Community Development Committee Report

Subject: Minnesota River Greenway Regional Trail Master Plan Amendment, Dakota County, Review
File No. 50016-2

Metropolitan Parks and Open Space Commission Report

Metropolitan Parks and Open Space Commission

Figure 1: Minnesota River Greenway Regional Trail (Segment 2) location in the Regional Parks System

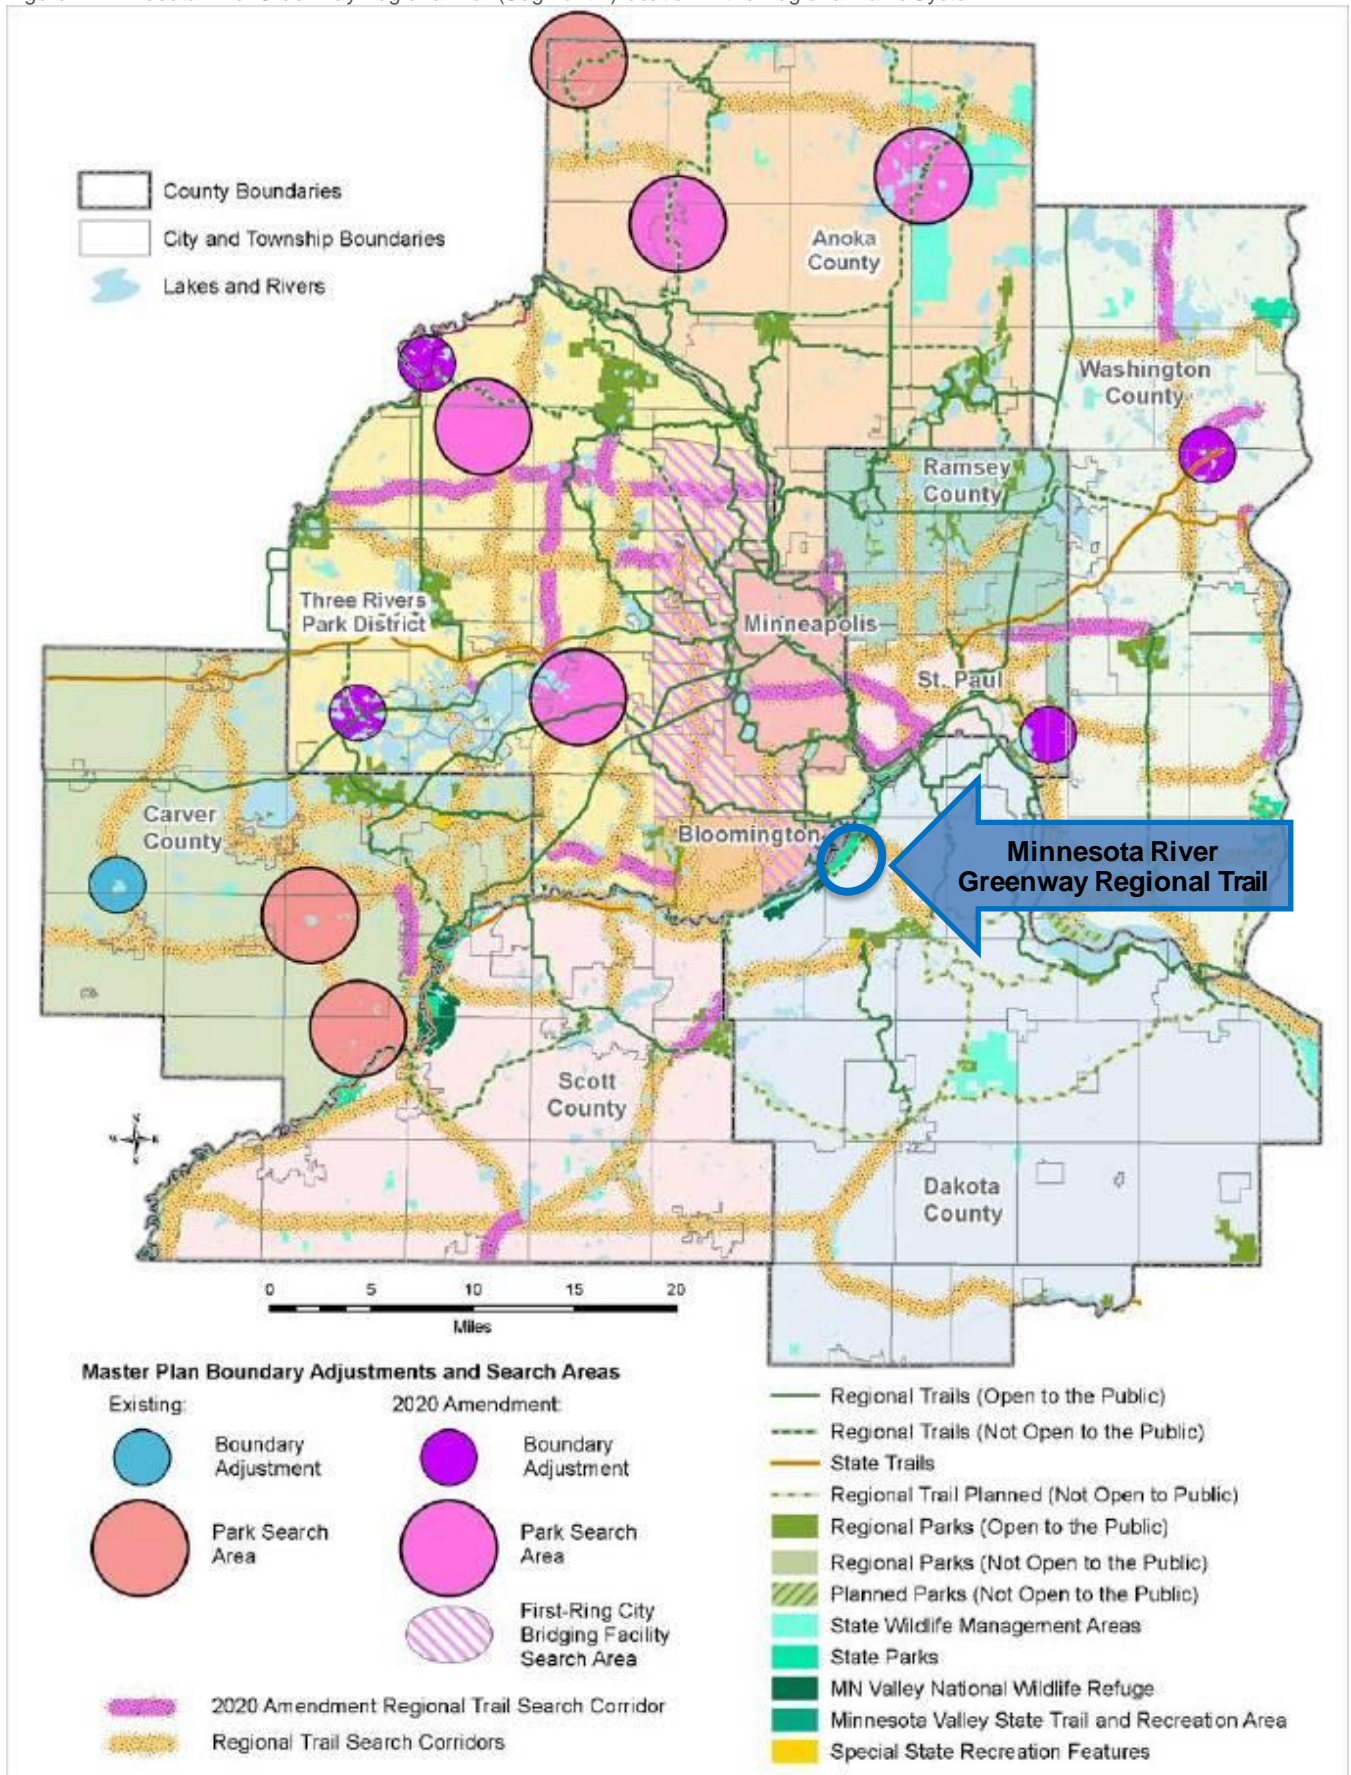
Transportation – Regional Bicycle Transportation Network (Steve Elmer, 651-602-1756) – Given its relevance to regional bicycle planning and potential federal transportation funding for trail construction, it would be advantageous to incorporate language and map elements that describe and reference the Regional Bicycle Transportation Network (RBTN). This could be most easily accomplished by inserting the RBTN route layers into the map shown in Figure 1 of the plan amendment and by adding a short paragraph within the "Development Concept" section.

Figure 3: Minnesota River Greenway Trail (MPA Figure 2)

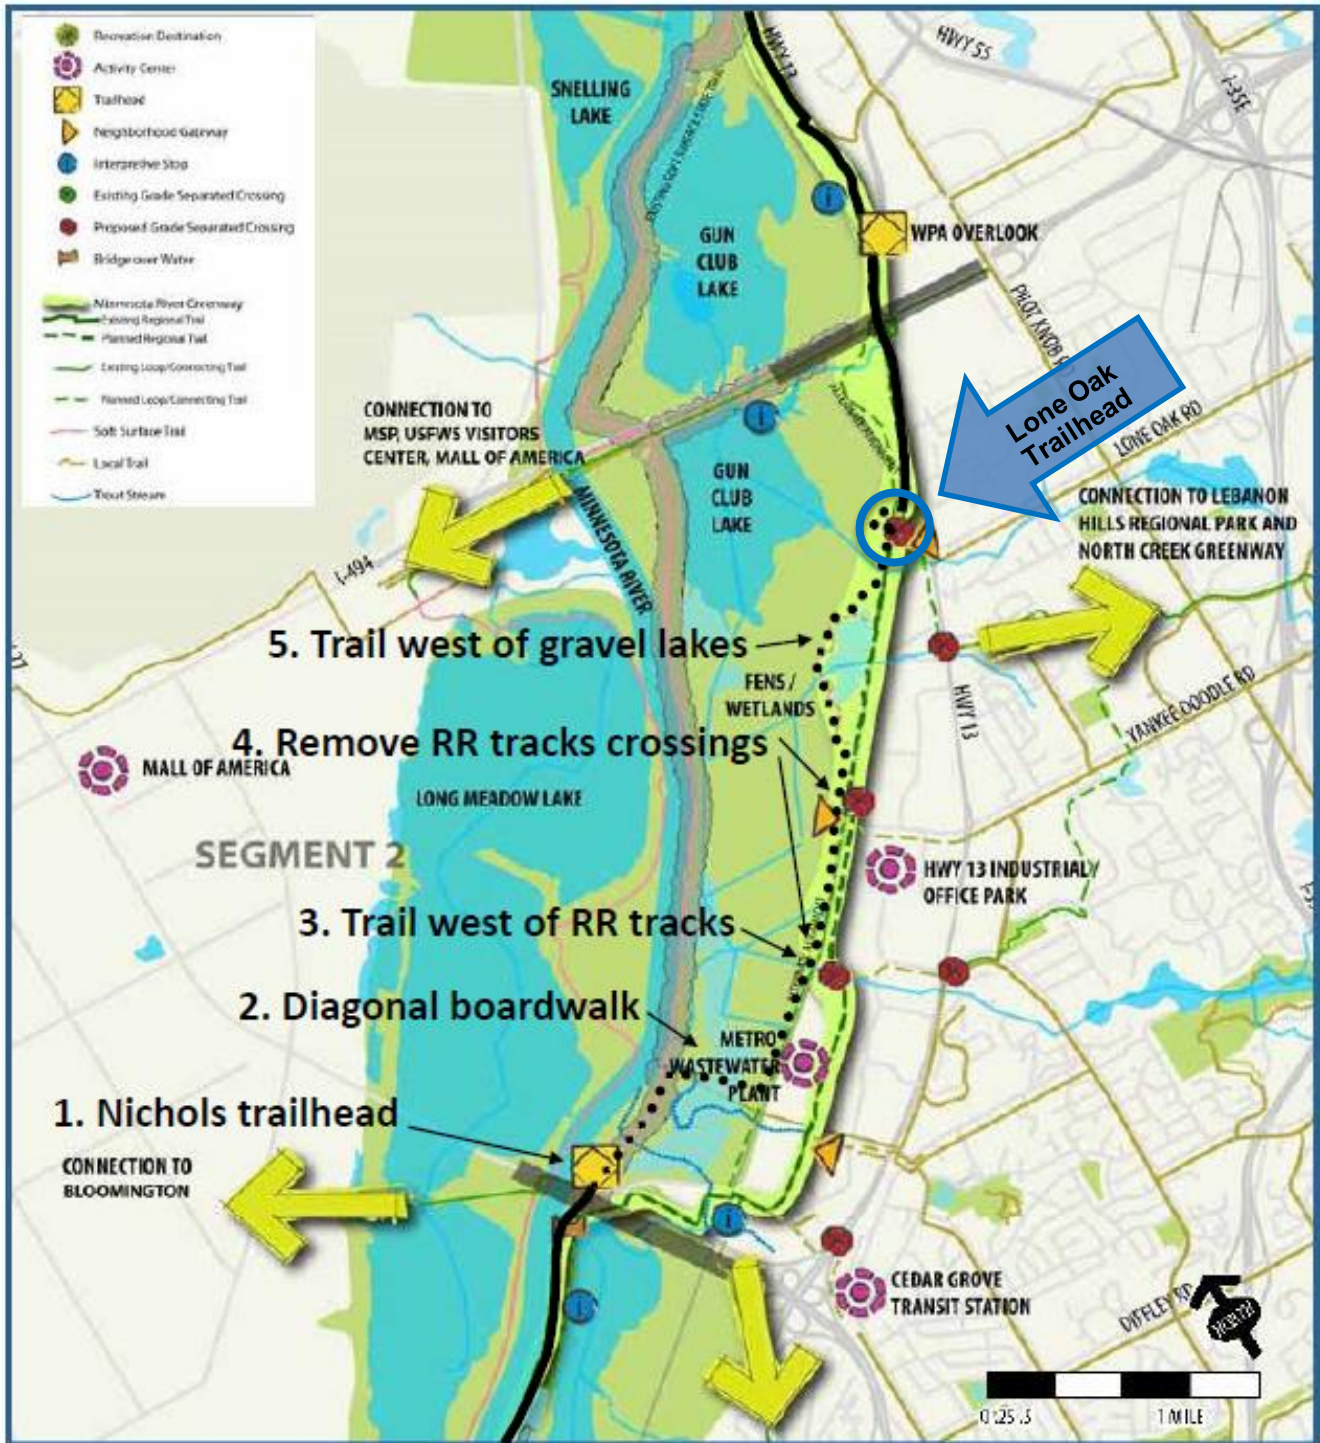
The updated alignment for the Fort Snelling State Park segment of the Minnesota River Greenway Regional Trail appears on Figure 3, overlain on the 2012 Plan concept map. The updated alignment connects and provides a continuous greenway trail from Burnsville to Harriet Island in St. Paul, and then south along the Mississippi River Greenway Regional Trail to Rosemount and Hastings. When complete, this segment will close an important gap between the existing Black Dog segment of the Minnesota River Greenway to the south with the Big Rivers segment to the north.

The 2012 Plan identified a preferred alignment and three alternative alignments to address the difficulty of locating a greenway trail in this segment of the corridor. The purpose of the alternative alignments in the 2012 Plan was to promote flexibility in designing a trail in this challenging location. The alternative referenced as the “Southwest portion” in the 2012 Plan most closely aligns with the updated trail alignment.
